Product Marking Change For Virtex-II, Virtex-II Pro and Virtex-4 FPGA Flip Chip Top Mark Ink To Laser Transition

XCN14019 (v1.1) June 18, 2014

Product Change Notice – For Information Only

Figure 1

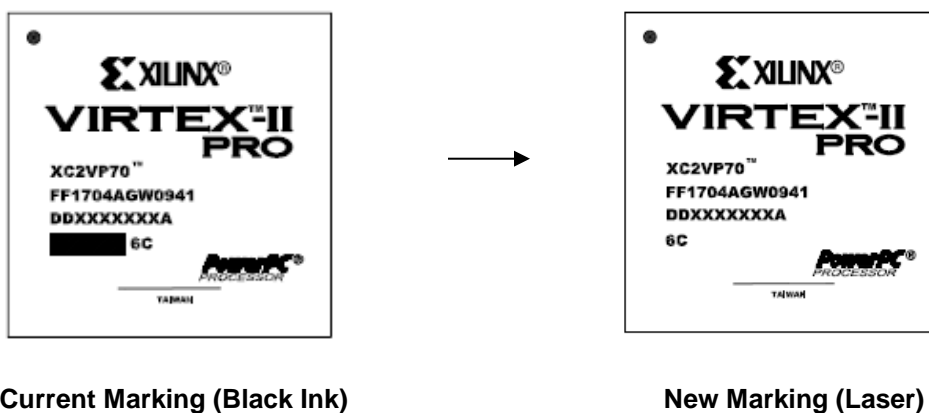
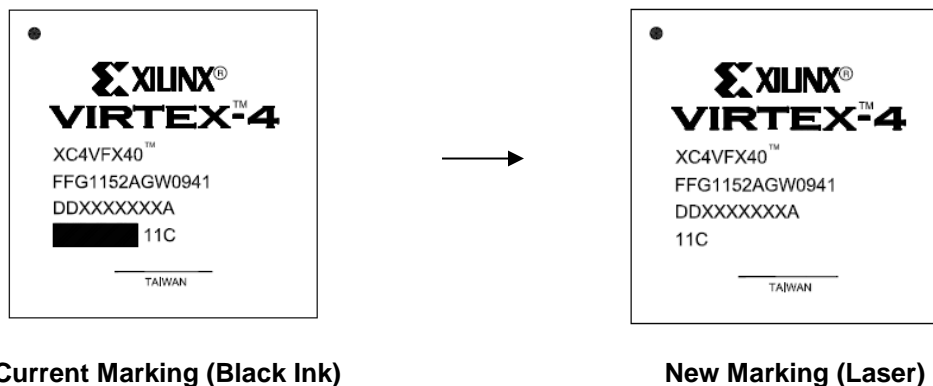
Xilinx will be converting the package top mark from ink to laser mark for all Virtex-II, Virtex-II Pro, and Virtex-4 FPGA Flip Chip packages.

Affected devices are identified by the following package top marks as shown in the [Figure 1](#) and [Figure 2](#).
